**NOTICE OF DECISION TO CONSENT TO CHANGE TO PROPOSAL DURING  
ASSESSMENT**

Yogi Magnetite Project  
Assessment No. 2154

**CONSENT TO CHANGE PROPOSAL DURING ASSESSMENT**

Figure 1: Section 43a pipeline development envelope

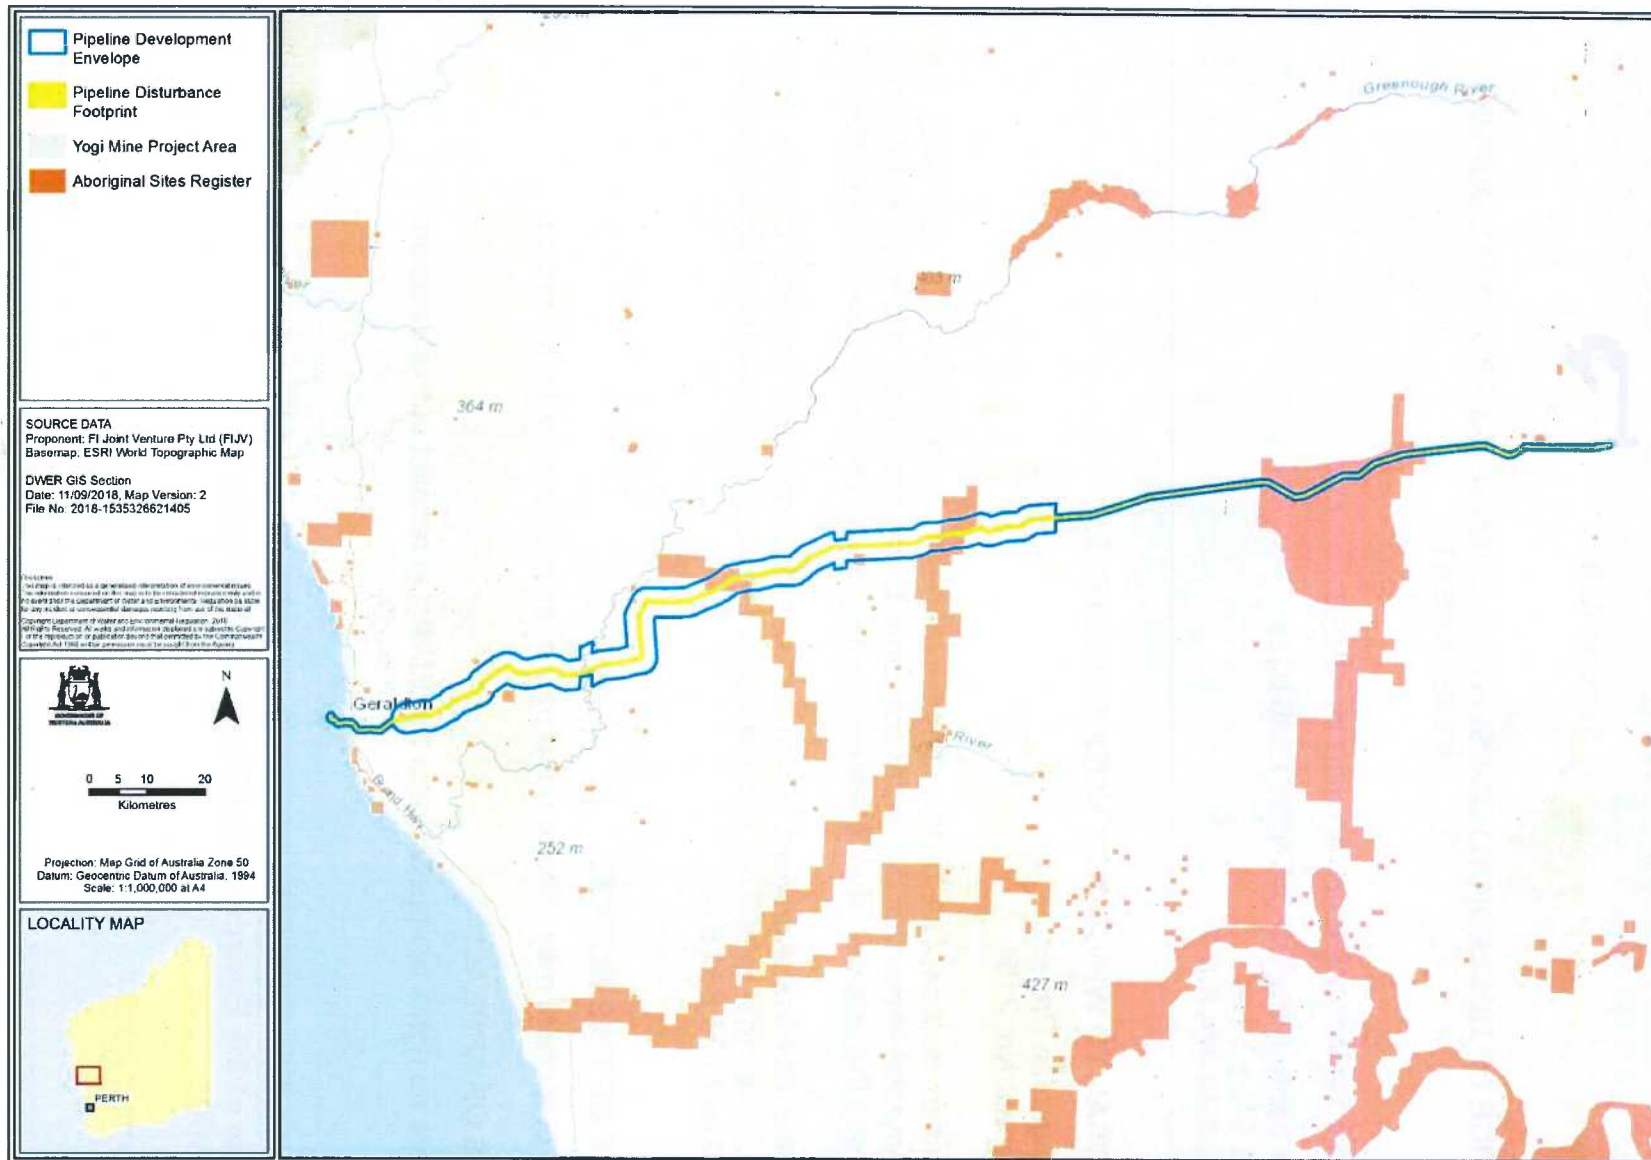
*Modify the pipeline alignment, which reduces the amount of required clearing from 1500 hectares (ha) to 600 ha, and the size of the pipeline development envelope from 383,850 ha to 76,800.5 ha.*

Figure 2: Section 43a pipeline development envelope

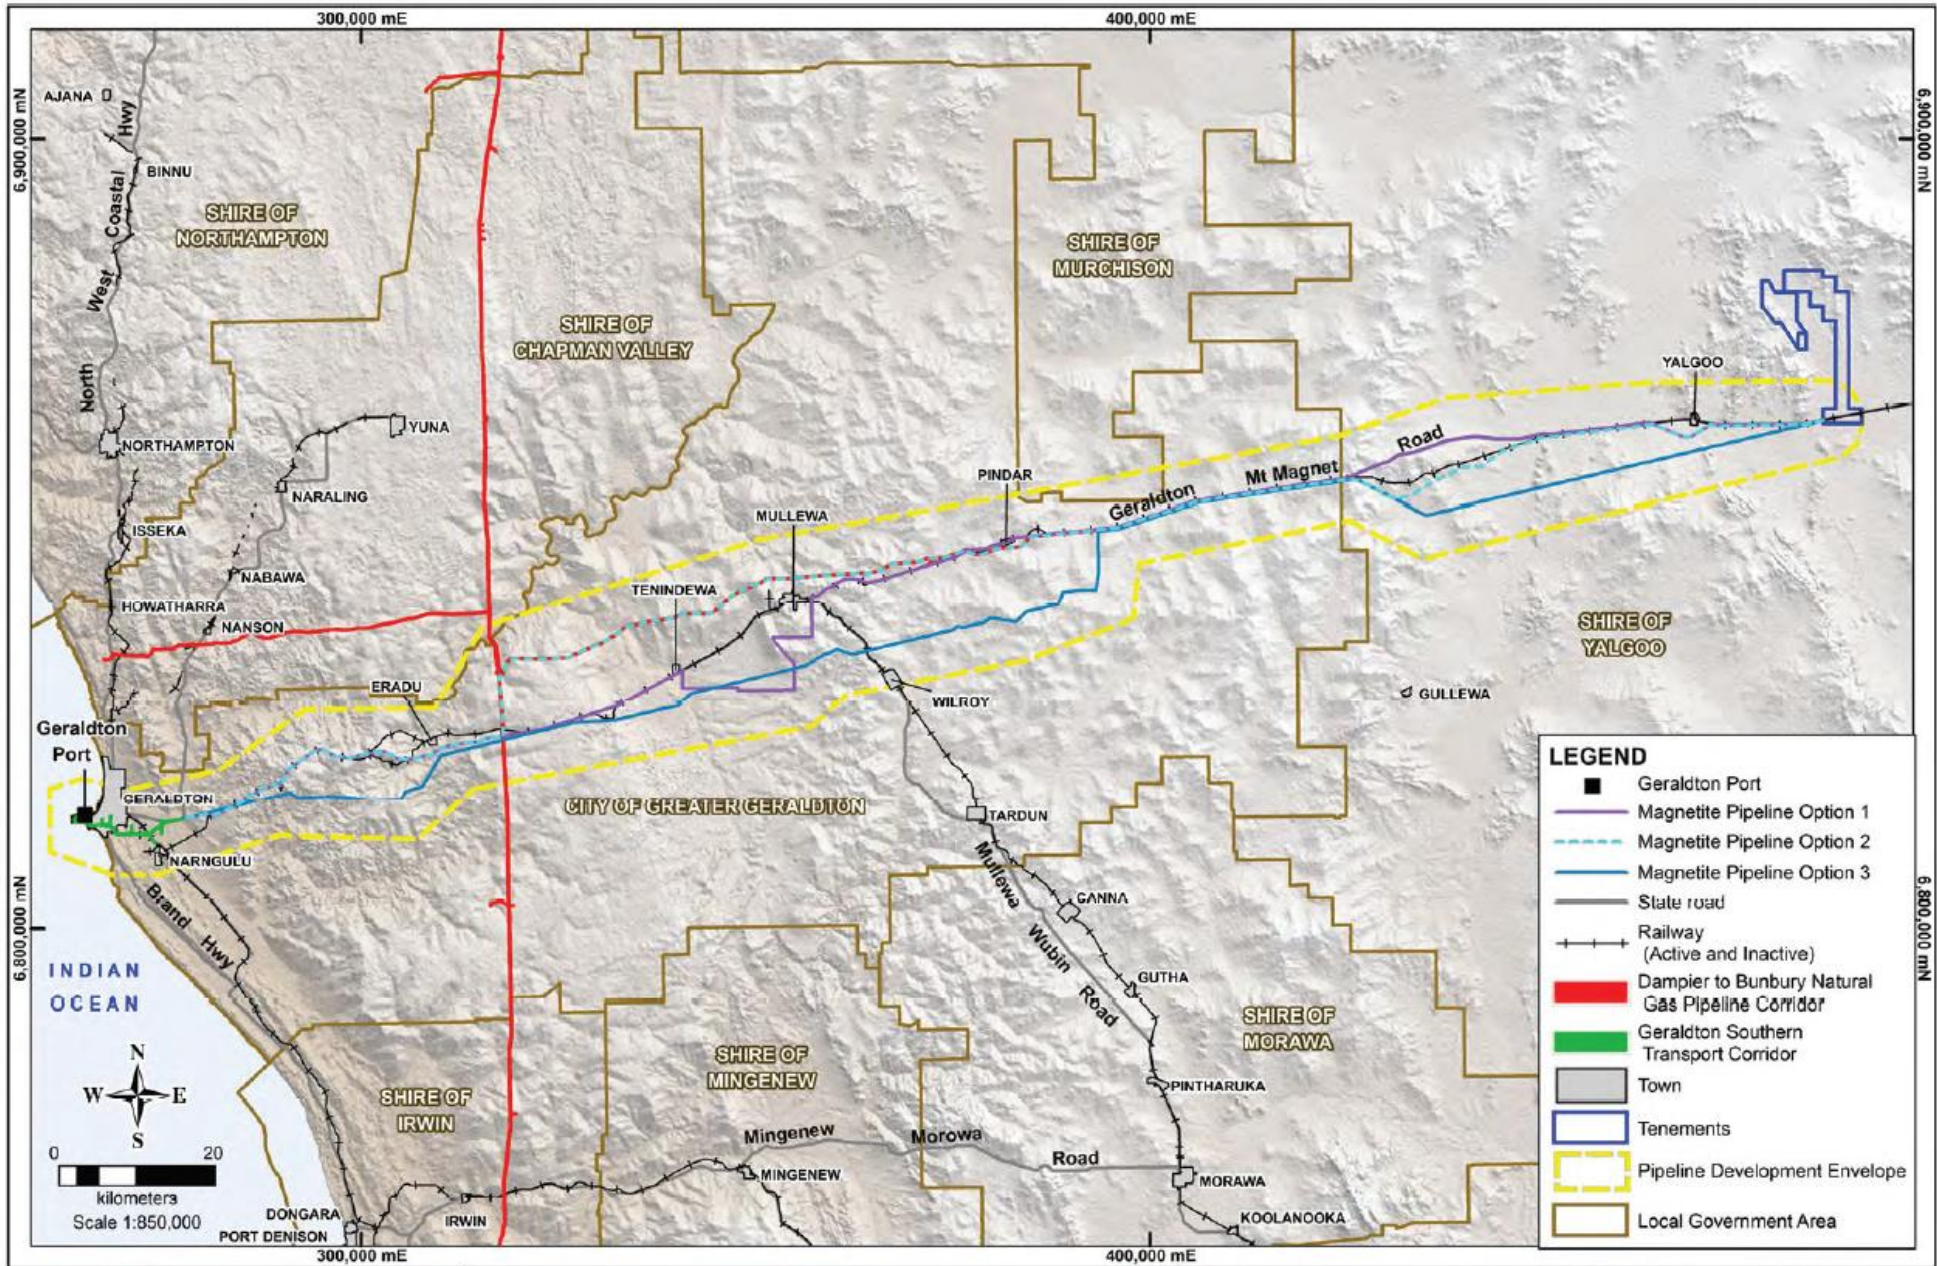
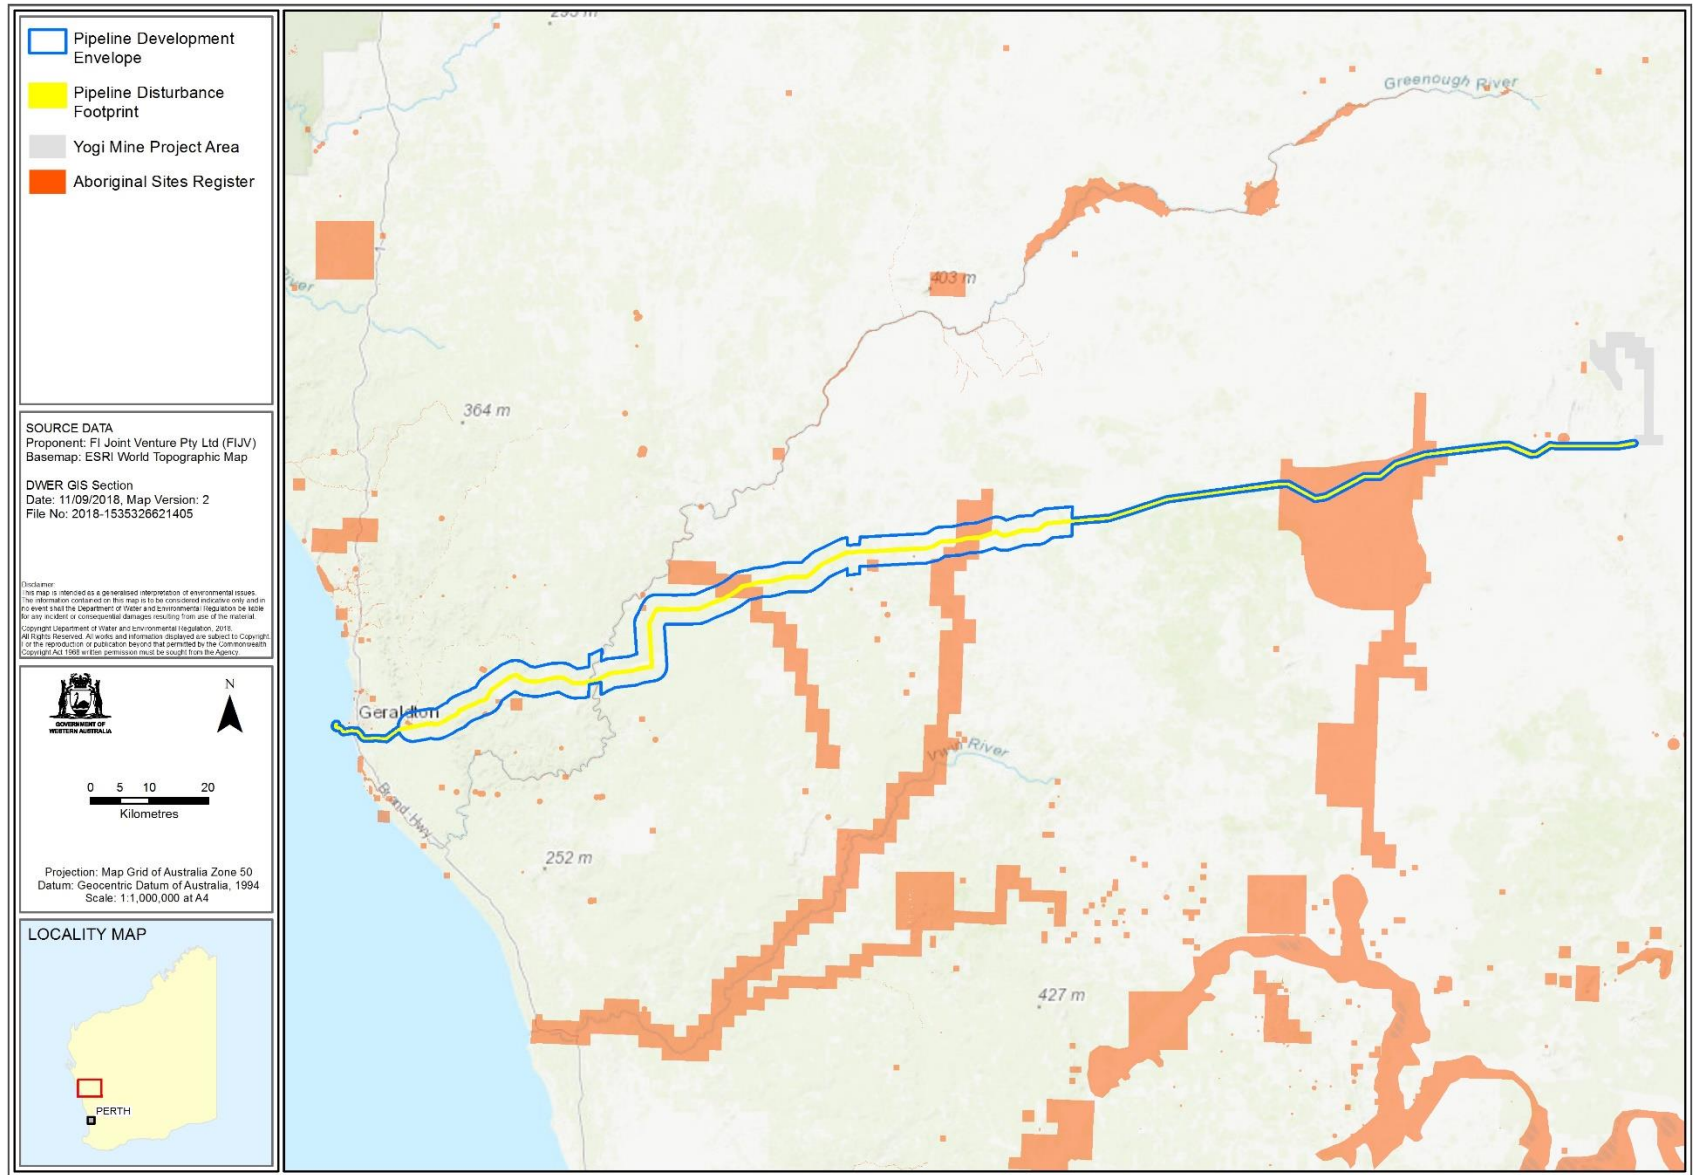
The proposed change would reduce the amount of clearing required for the pipeline from 1500 hectares (ha) to 600 ha, and the size of the development envelope from 383,850 ha to 76,800.5 ha. Figure 1 shows the original pipeline and Figure 2 shows the proposed pipeline alignment.

The proposed change would reduce the amount of clearing required for the pipeline from 1500 ha to 600 ha, and the size of the pipeline development envelope from 383,850 ha to 76,800.5 ha.

The proposed change would reduce clearing by 900 ha and the size of the pipeline development envelope by 307,049.5 ha. The environmental impacts from the proposal are likely to be reduced from the change to proposal.
